Albert Bridge House, Manchester

Stage 1 Road Safety Audit

Design Response Report

Curtins Ref: 085538-CUR-XX-XX-T-TP-00005

Appendix C – Swept Path Analysis drawing (Large Car)

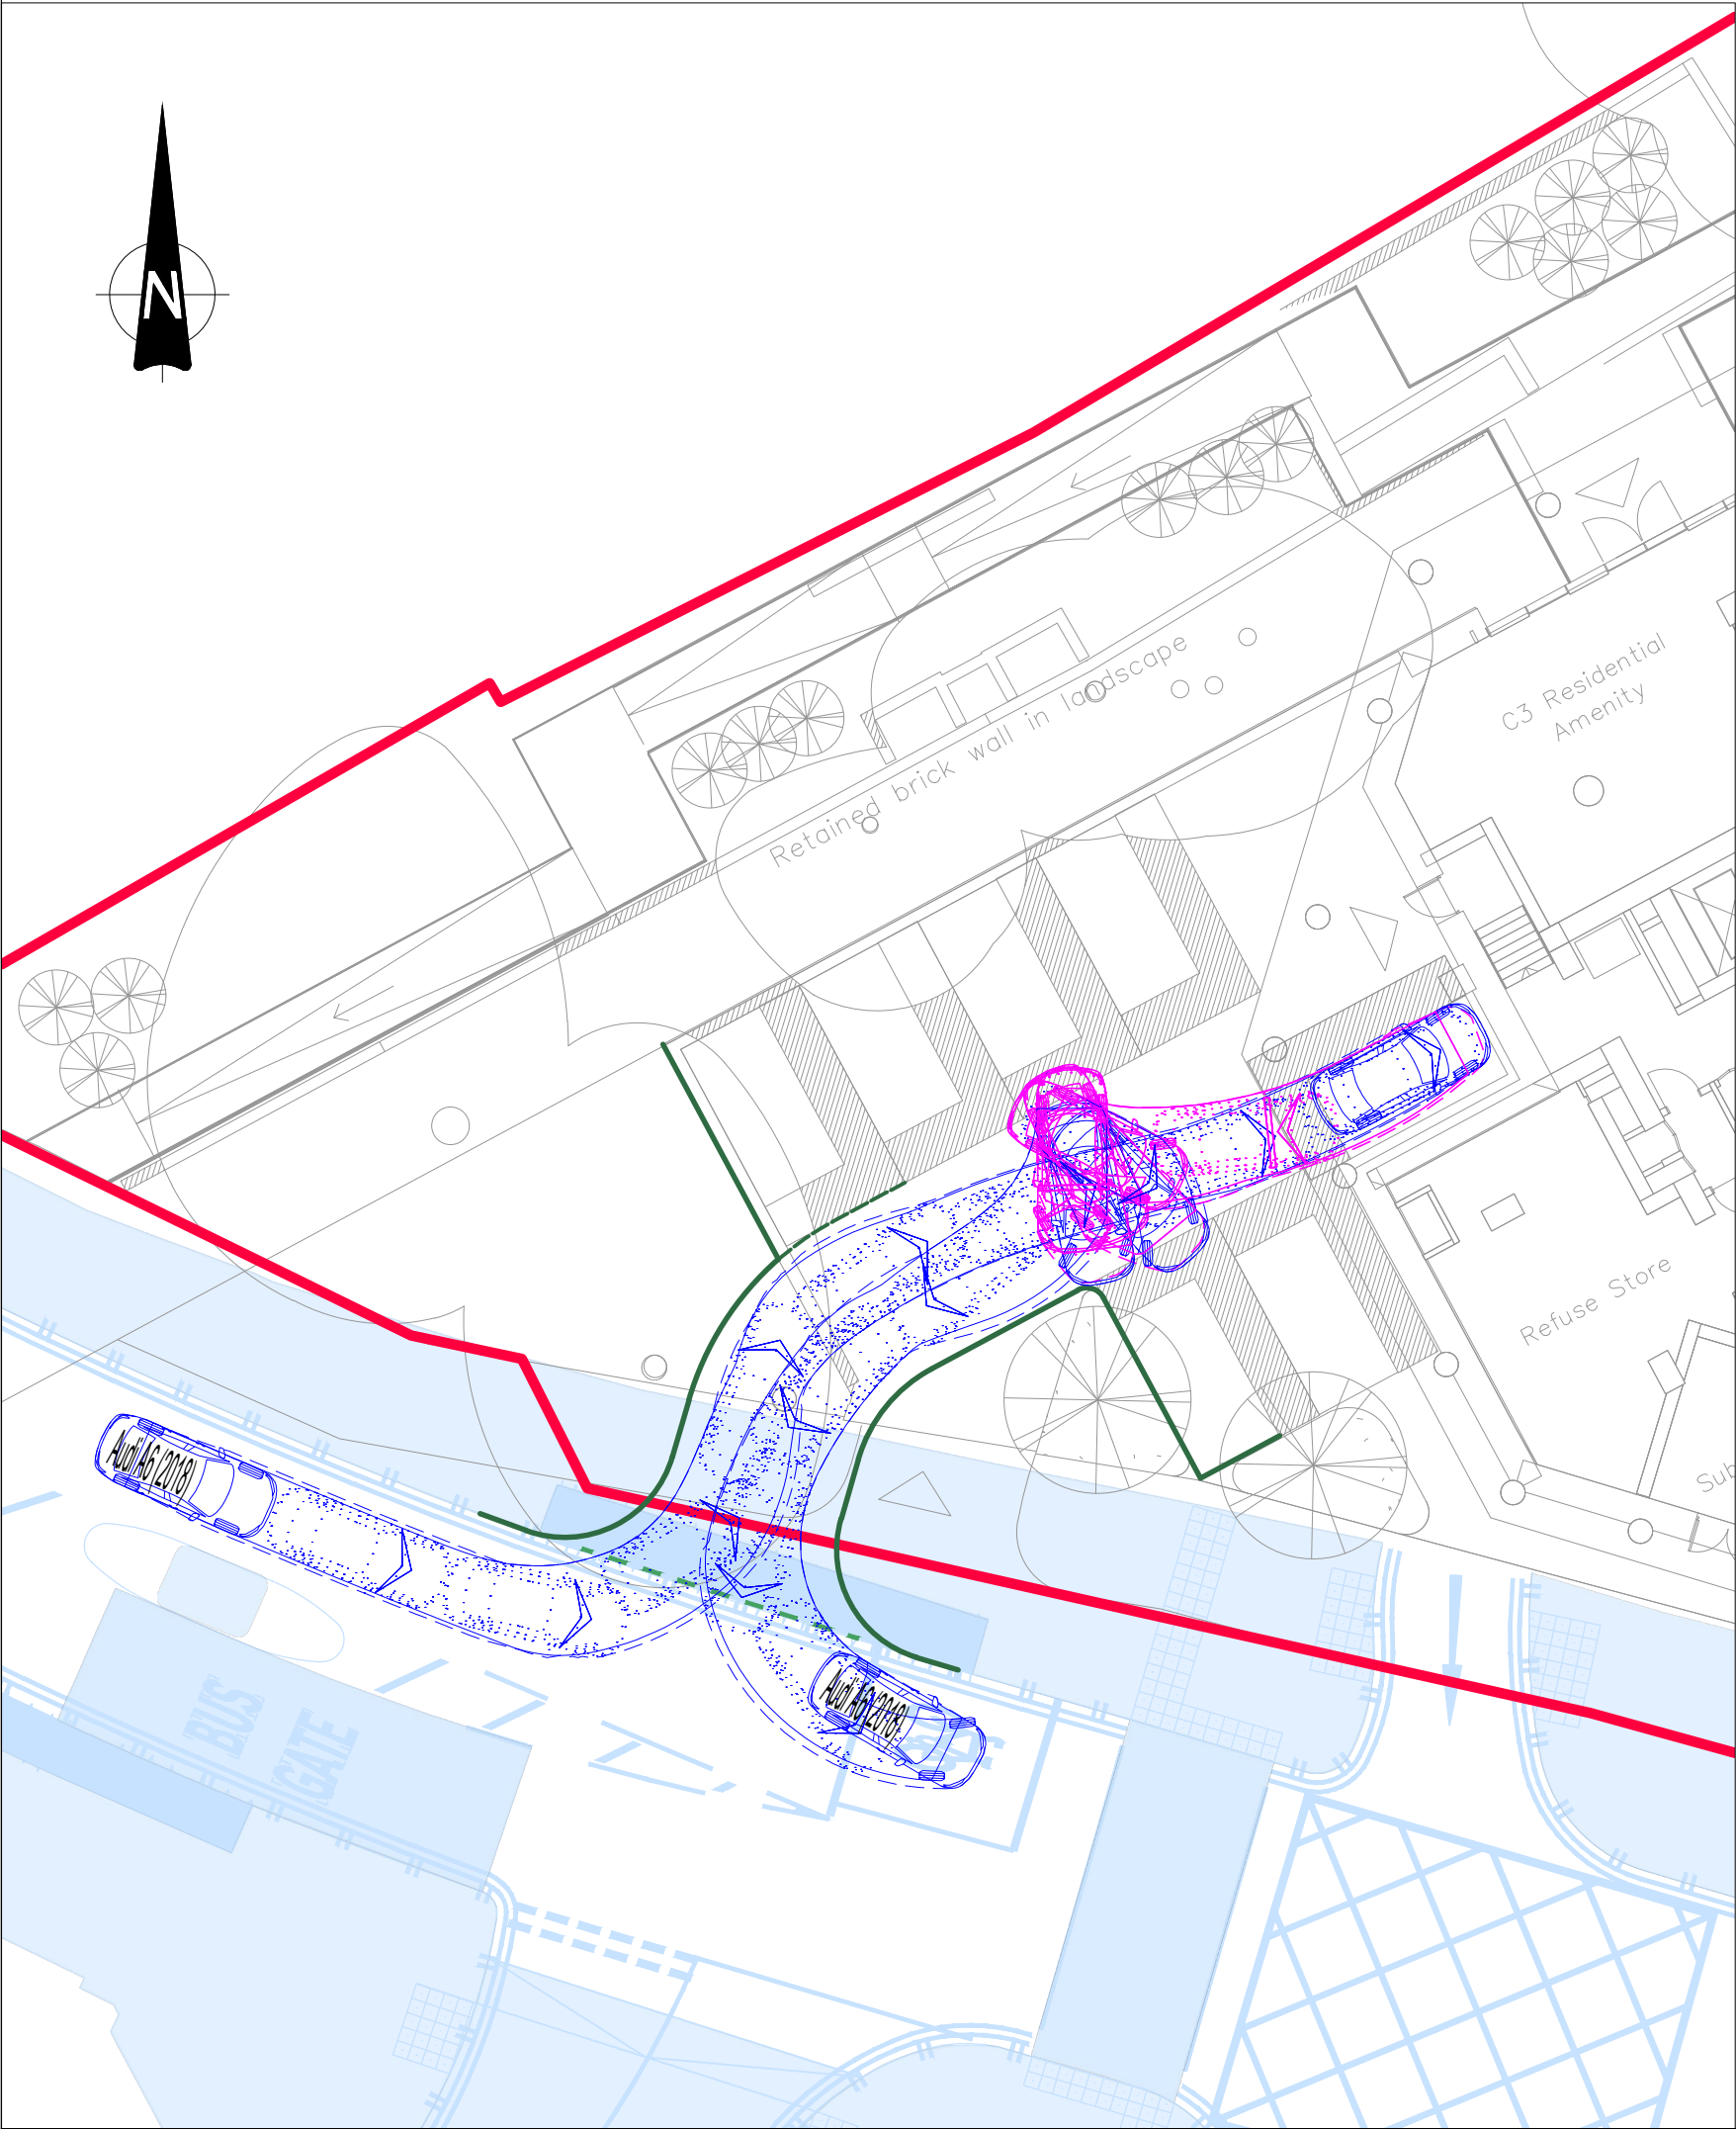
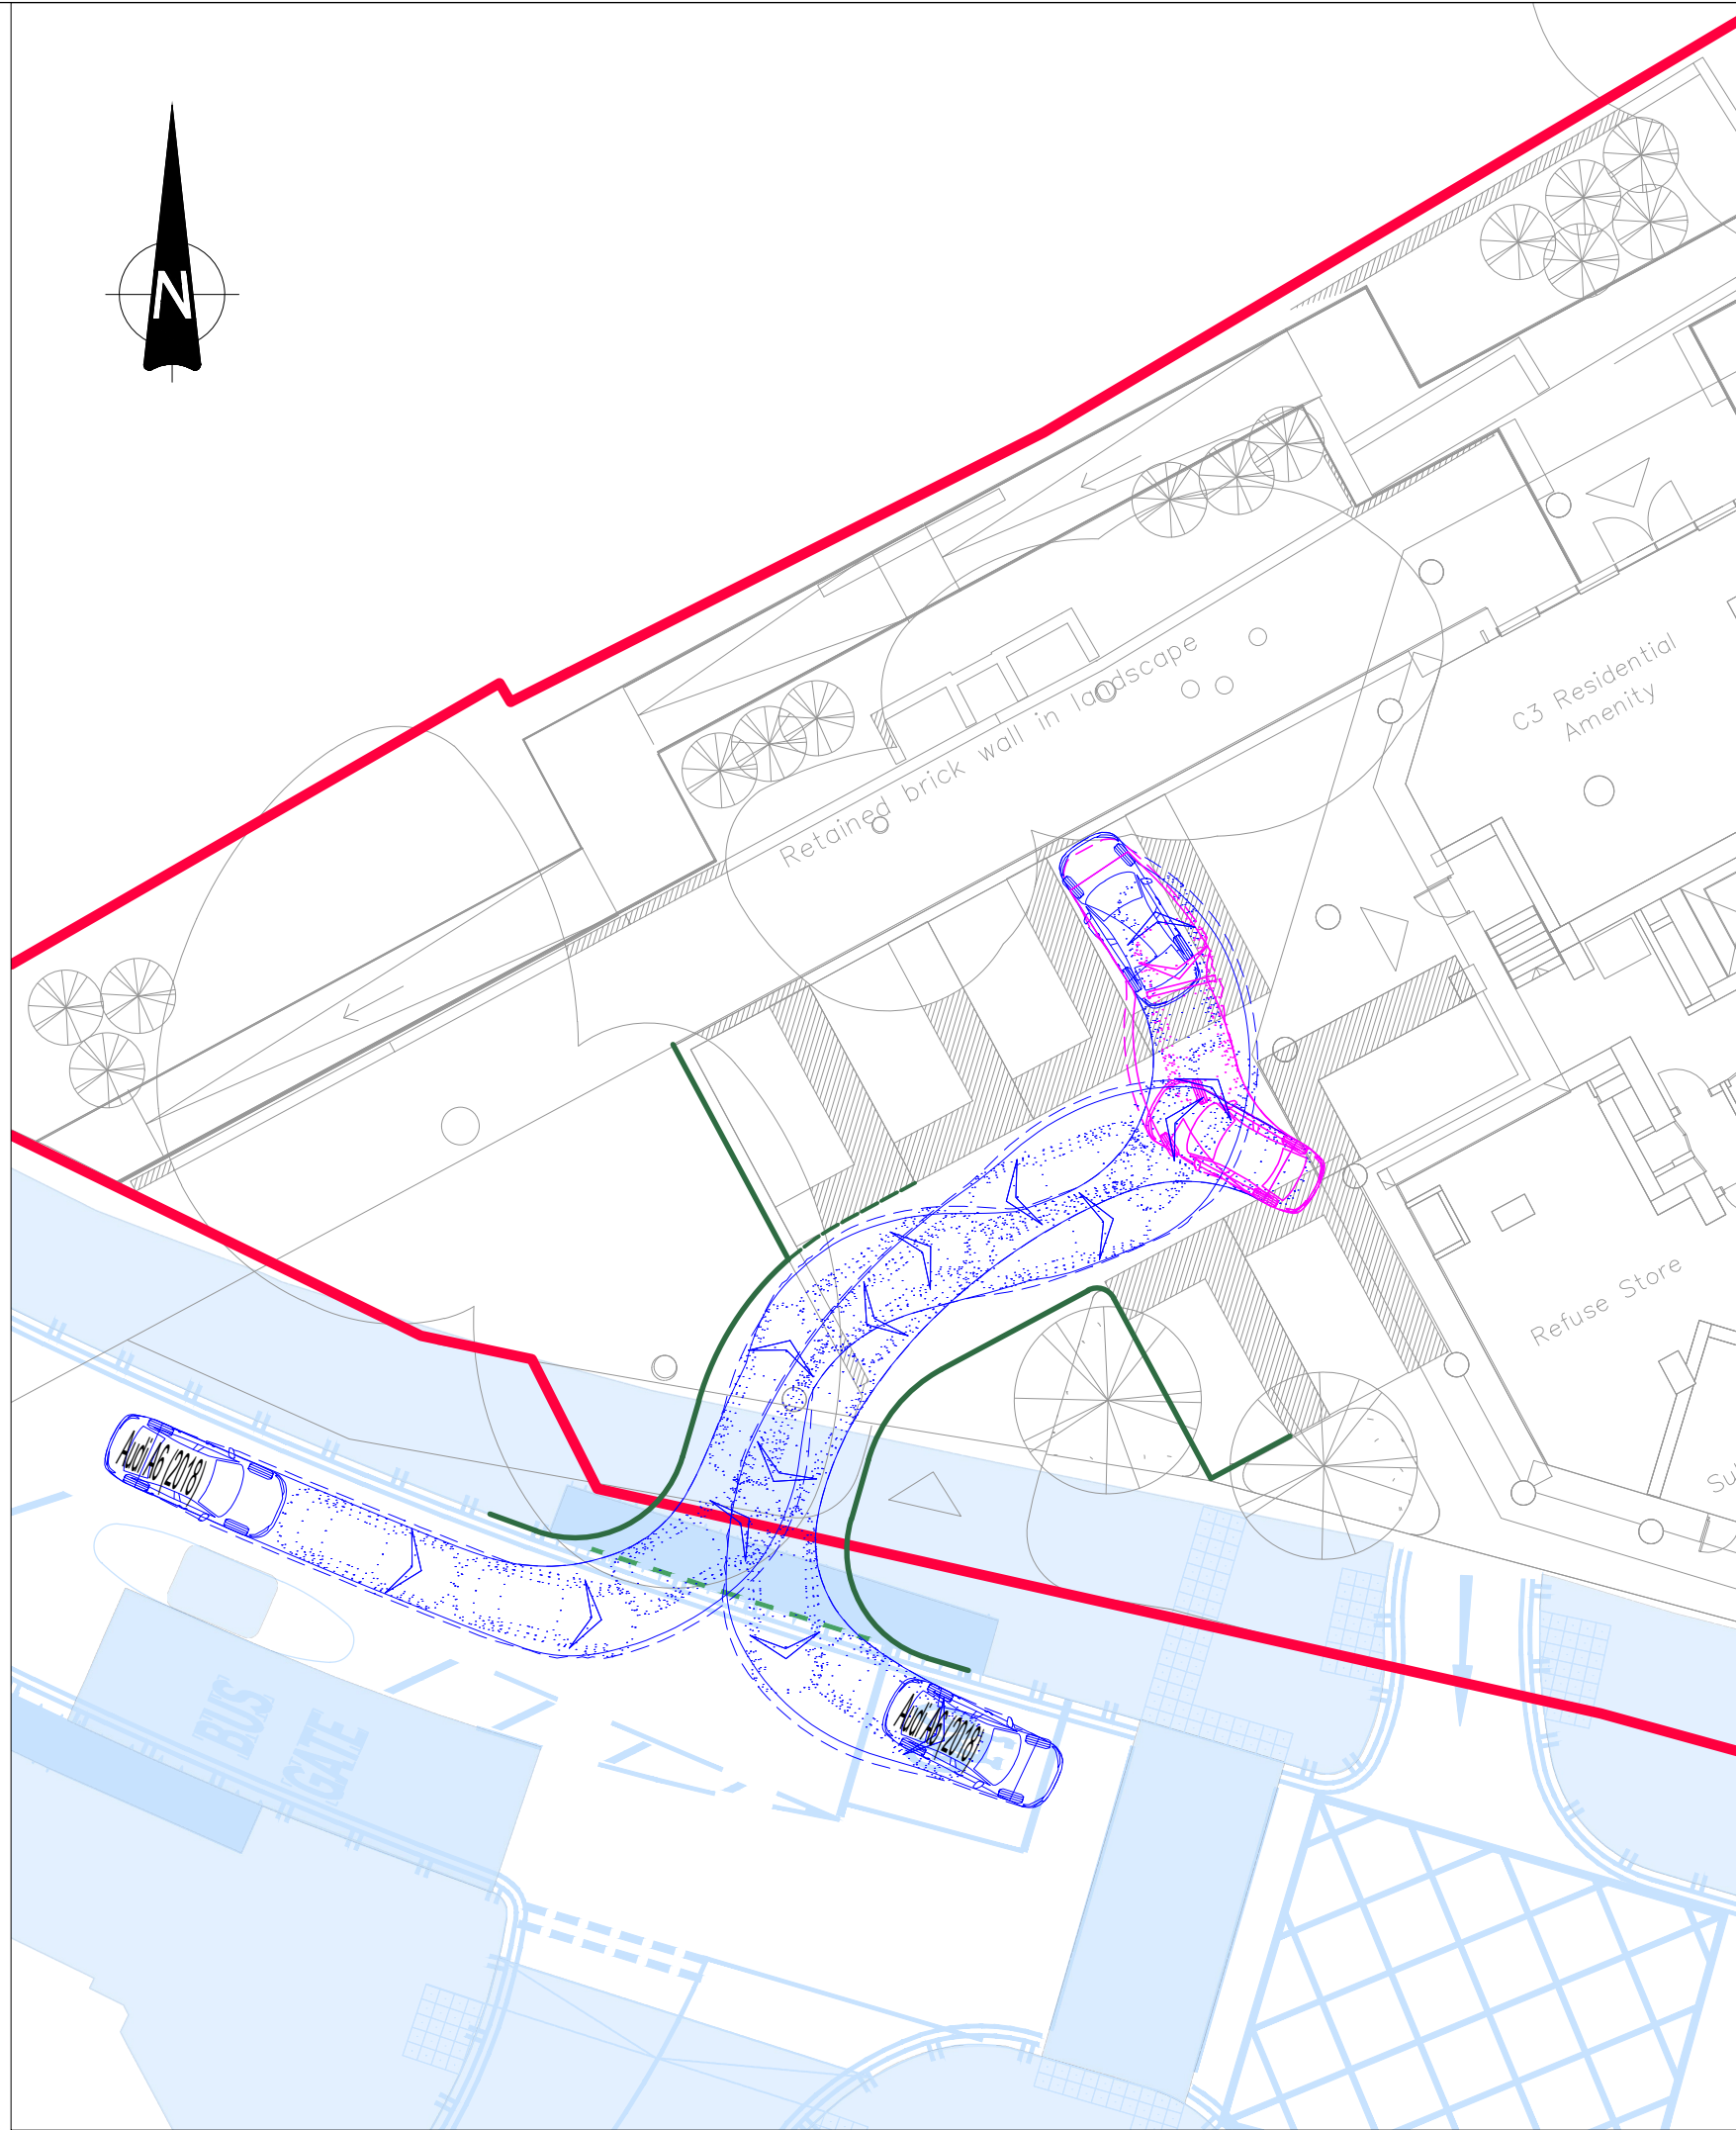
This access / egress will be newly constructed and located more towards a slight bend in Bridge Street. Although the alignment is good with a wide footway the auditor has no detail design proposal and note that there are existing large mature trees in the vicinity. The visibility afforded to drivers exiting the proposed development could be blocked by landscaping features resulting in side impact collisions between traffic on the main road and traffic emerging from the proposed development.

Ensure the visibility splay to the left and right are clear of obstructions by relocating the bus stop away from the visibility splays and restricting on-street parking.

There is a small refuge located in the vicinity of the planned access / egress and the audit team are concerned that this refuge may hinder drivers attempting to turn right out of the small car park which may result in unusual manoeuvres and conflict.

If right turn out of the car park is to be allowed, then the designer is to ensure there the refuge will not pose a problem for drivers turning efficiently and safely into Bridge Street.

Item	Location	Summary	Recommendation	Design Team Response
Problem – 4.1	Relocated access / egress (small car park) Bridge Street opposite Leftbank	Potential for restricted visibility to the right for traffic exiting the proposed development and potential for low-speed side impact crash types. This access / egress will be newly constructed and located more towards a slight bend in Bridge Street. Although the alignment is good with a wide footway the auditor has no detail design proposal and note that there are existing large mature trees in the vicinity. The visibility afforded to drivers exiting the proposed development could be blocked by landscaping features resulting in side impact collisions between traffic on the main road and traffic emerging from the proposed development.	Ensure the visibility splay to the left and right are clear of obstructions by relocating the bus stop away from the visibility splays and restricting on-street parking	The recommendation is accepted. Drawing ref.: “86313-CUR-XX-00-D-TP-75001” has been updated to revision P05 to show visibility splays in both directions from the proposed car park access. The updated drawing is shown in Appendix B
